Response to April 5, 2022- Planning Board Meeting Comments:

in particular this location, is that a household can easily access services and amenities without a vehicle.
<b>Detailed Plan Review Comments Recorded from the PB meeting on 04/05/2022:</b>

# 49 Sixth Street Renovation Cambridge, MA

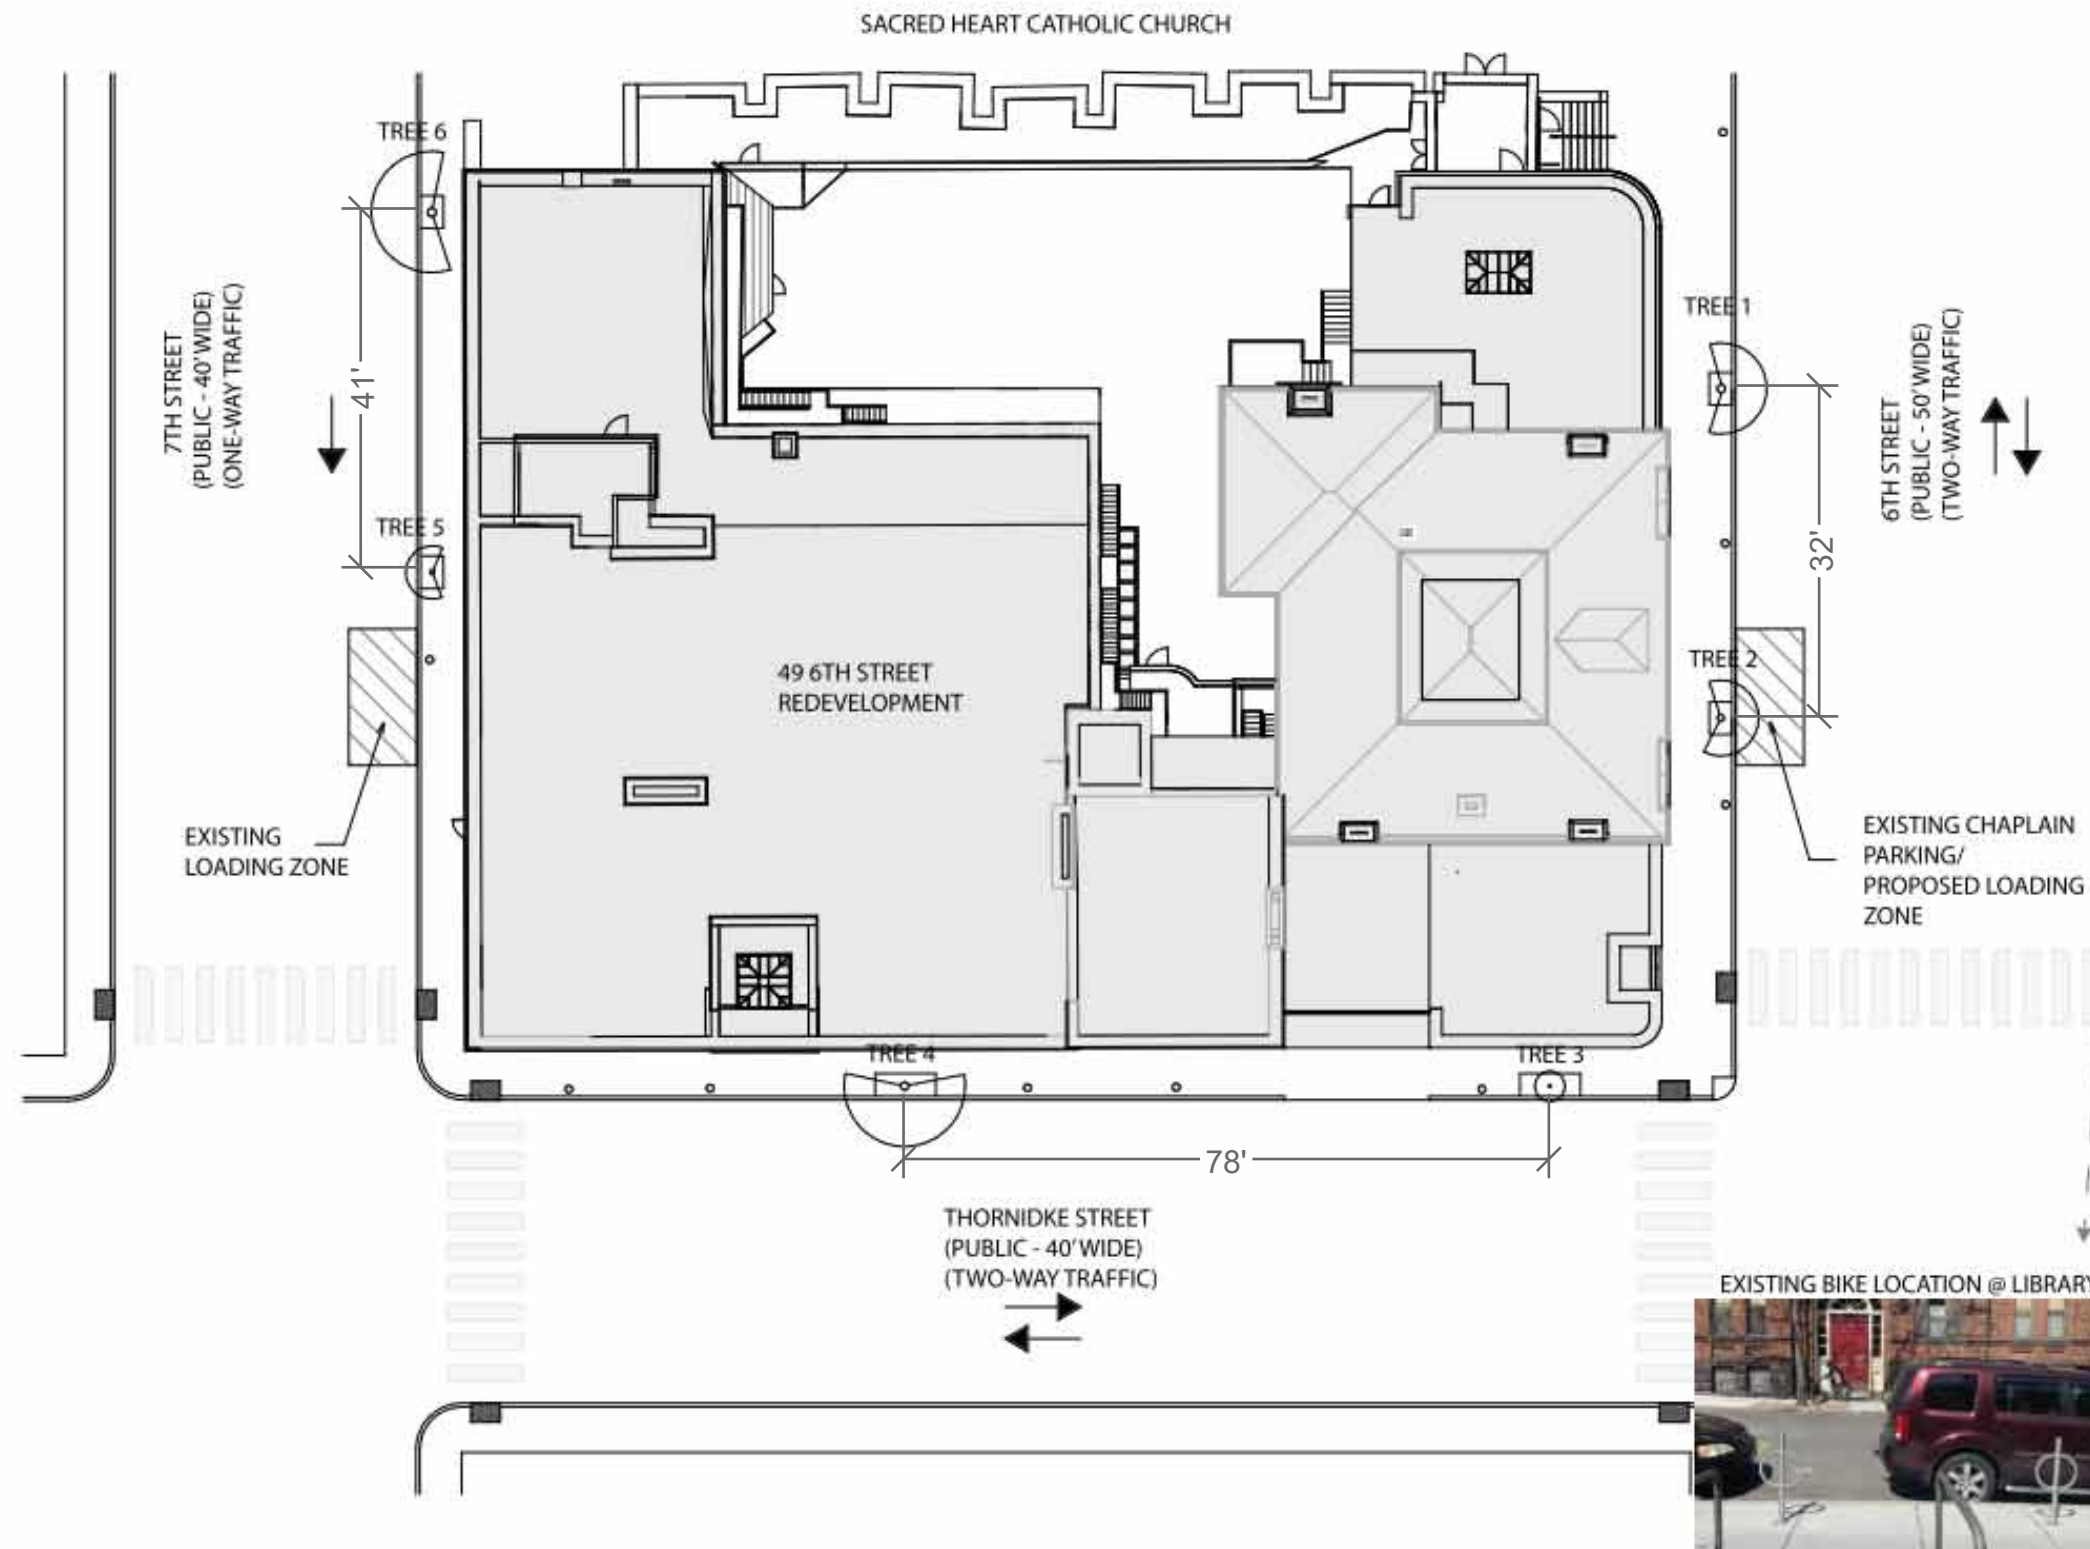
<ul style="list-style-type: none"> <li>• <b>Landscape.</b> Board members would like to see additional street trees. They would also like to understand what trees currently exist on site and any measures that will be taken to preserve them.</li> </ul>	<p>The applicant is willing to coordinate with DPW on location and replacement of street trees, but due to affordable housing budget constraints would not be able to incorporate new street trees into the affordable housing budget. Condition of the existing courtyard trees have been reviewed by the landscape team. Please refer to slides #3 and 4 in the revised slide package for additional information, as well as slide #9 for proposed plantings and site furniture.</p>
<ul style="list-style-type: none"> <li>• <b>Parking and Loading.</b> Board members would like more information on the discussions that the developer has had with the Traffic, Parking and Transportation Department about exploring off-site parking solutions.</li> </ul>	<p>The applicant recognizes the challenges associated with the site constraints that prevent the provision of off-street resident parking. In exploring off-site parking options, the team has identified that adjacent garages (One Kendall Garage and CambridgeSide) for households who may not need daily use of their vehicles. Access to One Kendall Garage will be enhanced in the future with the completion of the Grand Junction Pathway. The applicant would be open to a parking-share agreement with the Cambridge Public Library (O'Connell Branch) across the street, or other municipal building, but these conversations with the Traffic Department have not led to any concrete proposals to date. The applicant has reached out to St. Anthony's on Prospect Street as well as a nearby property owner on Cardinal Medeiros Avenue that has a large surface parking lot on its property to explore whether any opportunities to lease some parking spaces might exist. To date, the response has not been encouraging. We would support the City in evaluating opportunities to expand resident parking, such as metered parking by Ahearn Field that could transition to resident parking after 5pm, or other areas where a parking study might suggest that metered parking is underutilized after certain hours.</p> <p>We also have done some research into comparable properties to better understand car ownership rates, and at an anecdotal level understand that car ownership rates tend to be lower for households living at 30, 60, and 80 percent of Area Median Income due to their significant expense. One of the attractions of living in Cambridge, and</p>

- EXISTING STEEP SLOPE NEEDS TO BE FLATTENED FOR ACCESSIBLE AND USABLE COURTYARD SPACE

- VOLUNTEER SAPLINGS  
-VARIOUS INVASIVE SPECIES AND NON-NATIVE  
VOLUNTEER TREES

- ARCHITECT CONCERNED WITH THE TREES' PROXIMITY TO THE BUILDINGS

② UNIT 40 ANNEX  
3/64" = 1'-0"

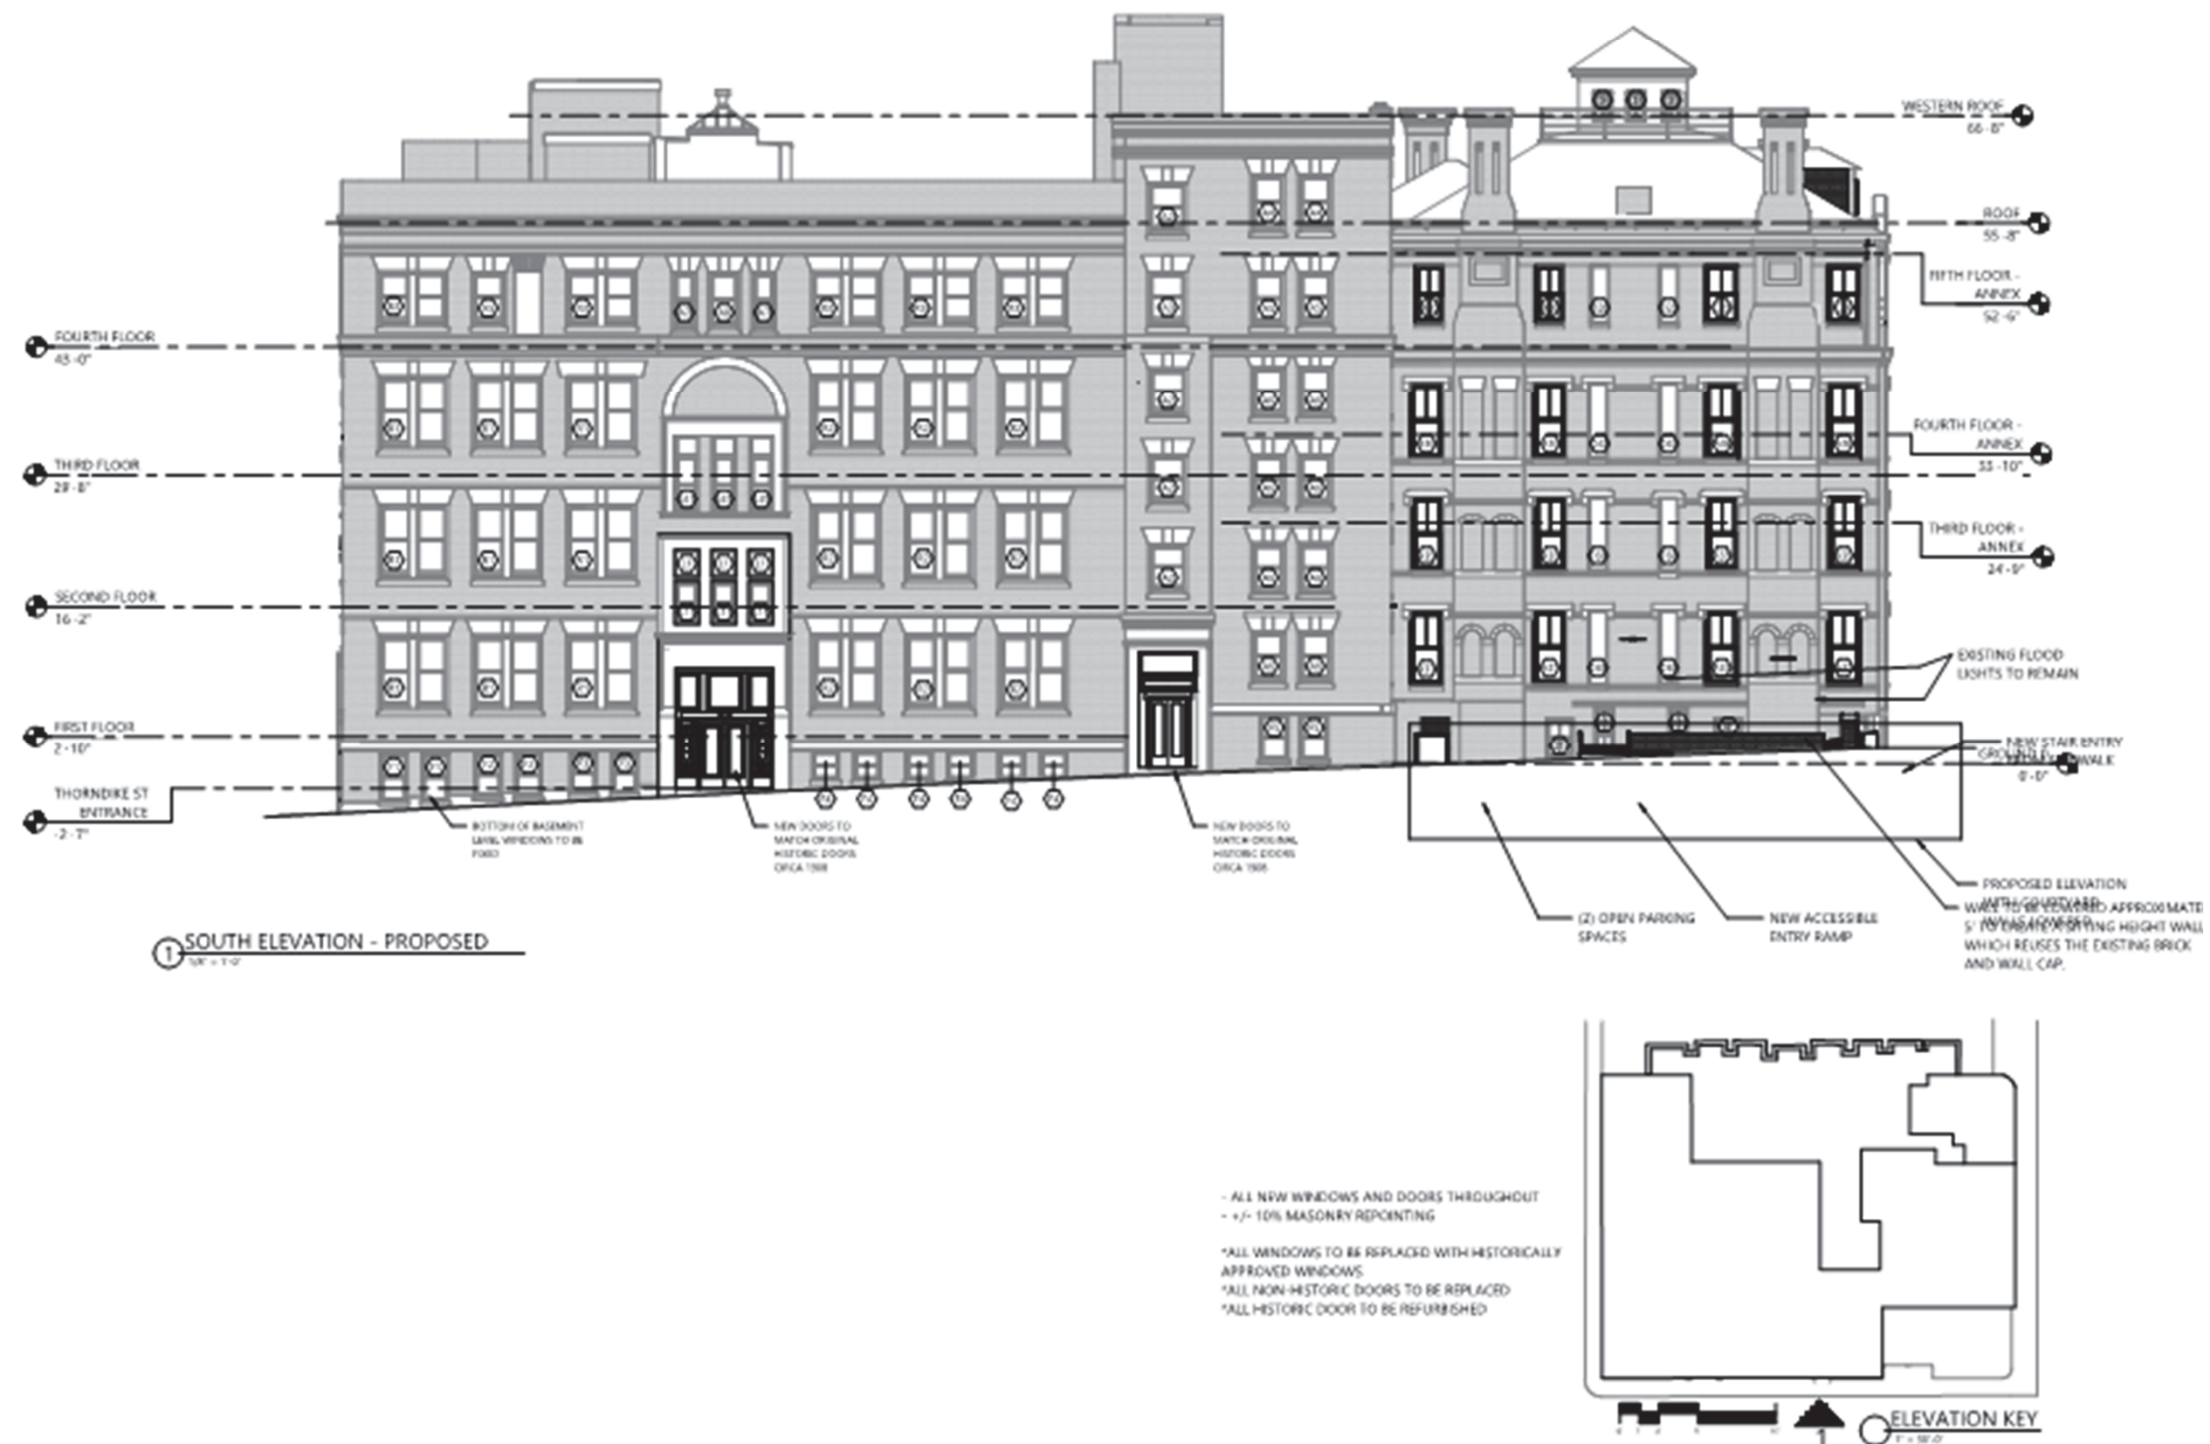
- Unit 40 – Elevation arrows	Corrected, please refer to slide # 14- Proposed Fourth floor plan
- Unit 36 – 2BR but looks like it contains 3BR.	Corrected, please refer to slide # 14- Proposed Fourth floor plan
